UNITED STATES PATENT AND TRADEMARK OFFICE

APPLICATION NO.	FILING DATE	FIRST NAMED INVENTOR	ATTORNEY DOCKET NO.	CONFIRMATION NO.
08/811,152	03/04/1997	YOSHIHARU HIRAKATA	07977/132001	9805

Office Action Summary

DETAILED ACTION

Figure 4A

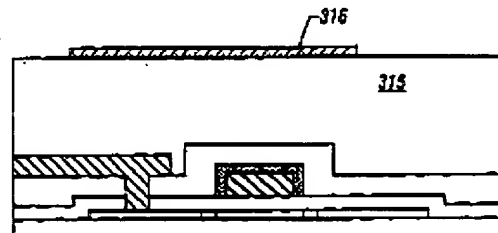
4. Yamazaki discloses and shows in Figs. 3A and 4A-4B, a liquid crystal display device (col. 1, line 6) comprising:

- a second interlayer insulating film (315) (applicant's first interlayer insulating film) comprising an organic resin over the thin film transistor;
 - a common electrode (316) having a function of black matrix over the first insulating film (315);
 - a third interlayer insulating film (317) (applicant's second interlayer insulating film) over the common electrode (316);
 - a pixel line and at least one pixel electrode both formed over the second interlayer insulating film (317), the pixel electrode extending from the pixel line;
 - a liquid crystal layer over the pixel line and the pixel electrode;
- wherein the pixel electrode is electrically connected to the thin film transistor through the pixel line; and
- a storage capacitor (319) formed between the pixel line and the black matrix.

Figure 4B

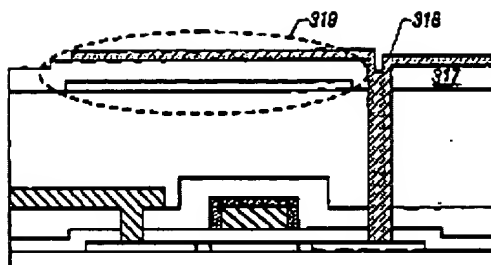
As to claims 145, 152 and 159, it is clear from figure 4B of Yamazaki that the second interlayer insulating film (315) (applicant's first interlayer insulating film) exhibits excellent flatness and thus serves as a planarization film.

6. Yamazaki discloses a liquid crystal display device comprising a thin film transistor connected with the pixel electrode and having, as an active layer, a semiconductor layer. See Fig. 4B.

As to claim 165, it is clear from figure 4B of Yamazaki that the second interlayer insulating film (315) (applicant's first interlayer insulating film) exhibits excellent flatness and thus serves as a planarization film.

10. Yamazaki discloses a liquid crystal display device comprising a thin film transistor connected with the pixel electrode and having, as an active layer, a semiconductor layer. See Fig. 4B.
